DEPARTMENT OF HIGHWAYS ONTARIO

MEMORANDUM

Tecumseh Park Bank Slippage near Hwy. #2 -
Approximately 2.0 Miles East of Thamesville
District #1 (Chatham)

SUGGESTED REMEDIAL MEASURES
 TECUMSEH PARK BANK SLIPPAGE-THAMES RIVER
 HWY. 2 APPROX. 2 MILES EAST OF THAMESVILLE

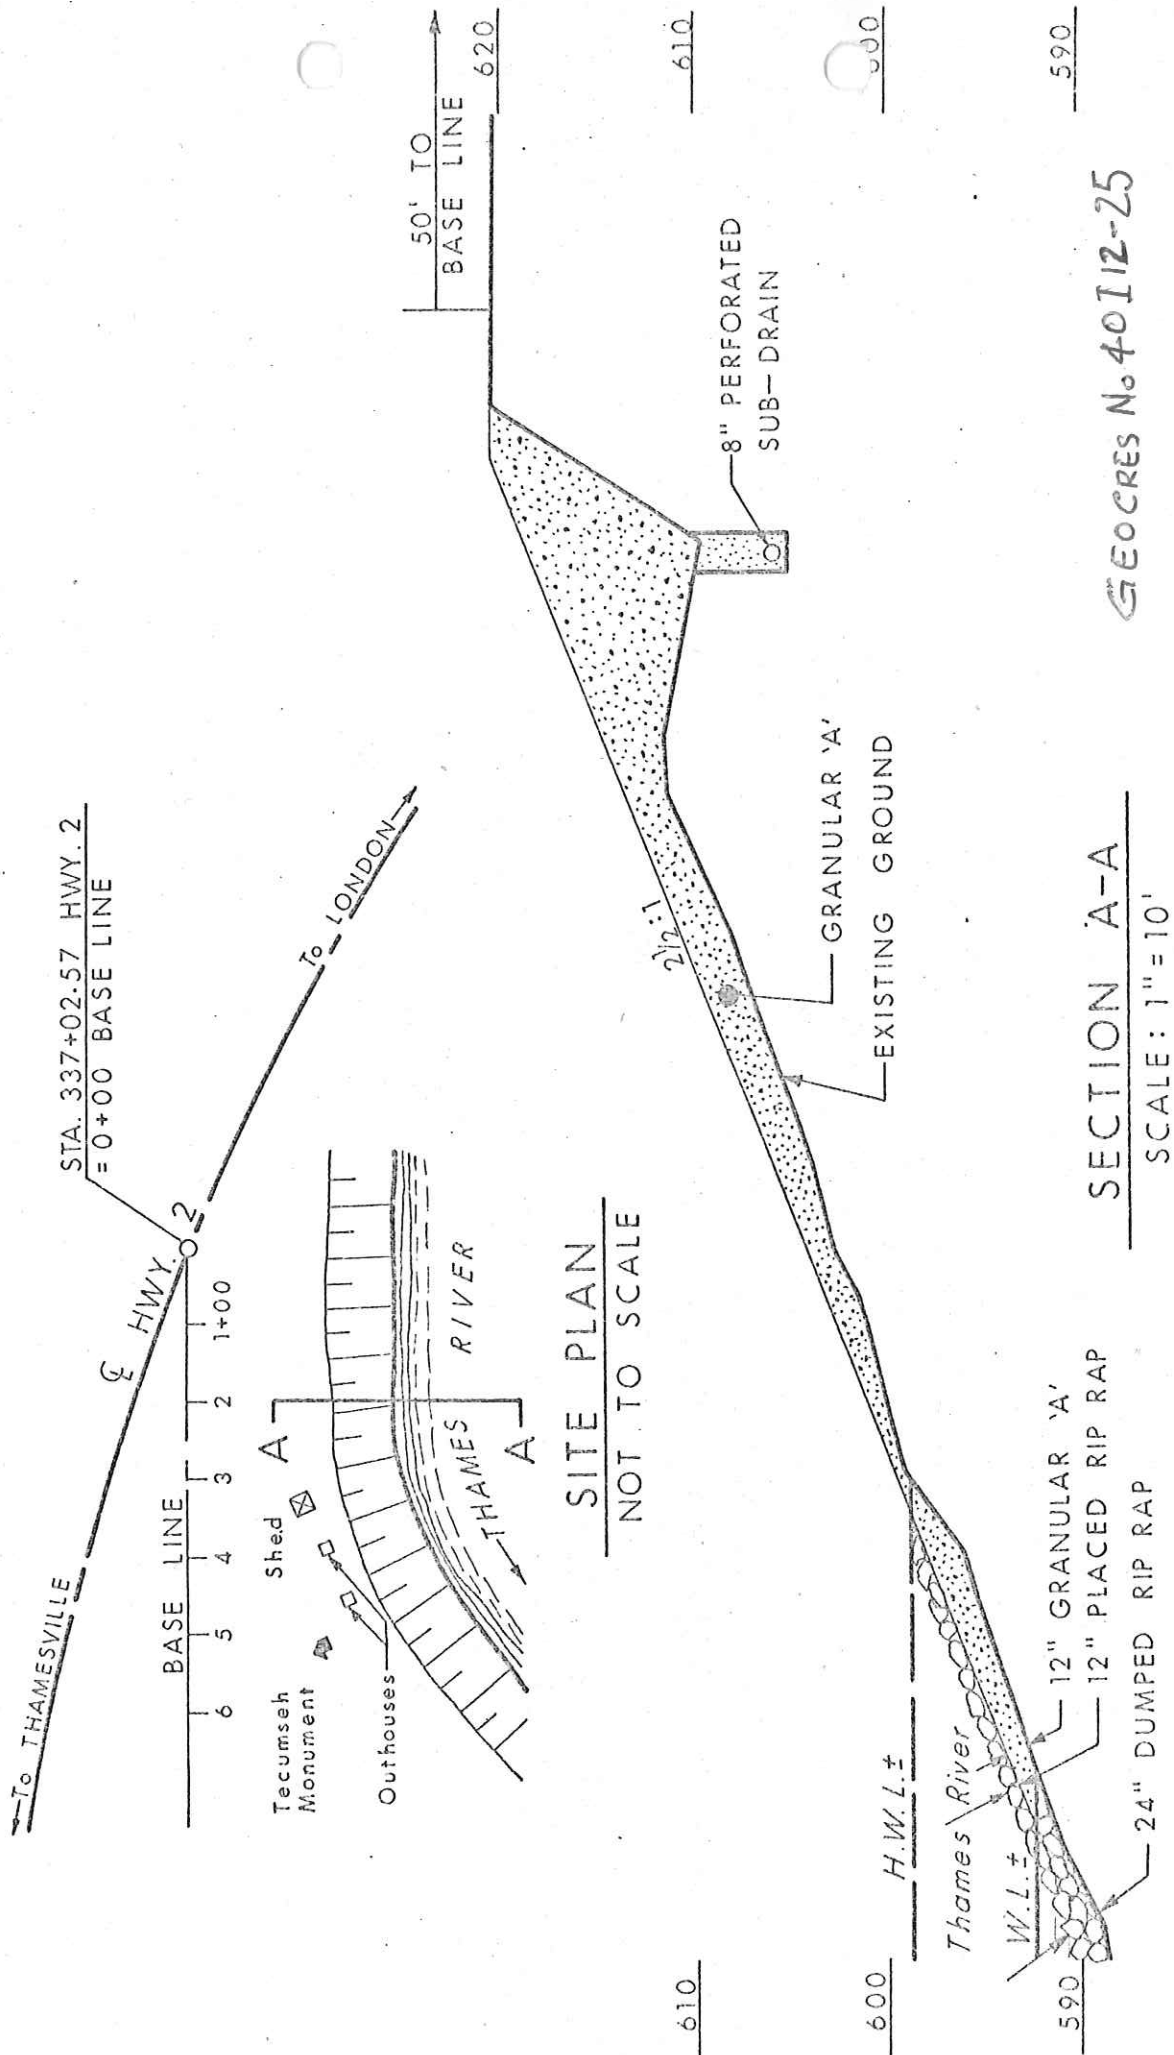
i) All the loosened material in the affected area on the river banks should be removed.

ii) Random rip-rap of at least 24 inches in thickness should be dumped at the toe of the river bank up to N.W.L. (Normal water level).

iii) Positive drainage measures should be adopted to relieve pore pressure buildup due to the spring water system in the upper 10 to 15 ft. of the river bank material. This can be achieved by means of an 8" ϕ perforated sub-drain, as shown on the enclosed drawing. The sub-drain should have a minimum cover of at least 4 ft. for frost protection. It is essential to provide outlets for the sub-drain and these outlet pipes must be prevented from freezing.

iv) A granular blanket, consisting of a free-draining material, such as Granular 'A', should be placed on the slope, as shown on the enclosed drawing. The blanket should have a minimum thickness of at least 12 inches.

v) Place additional rip-rap on top of the granular blanket above the normal water level and up to high water level of the river.
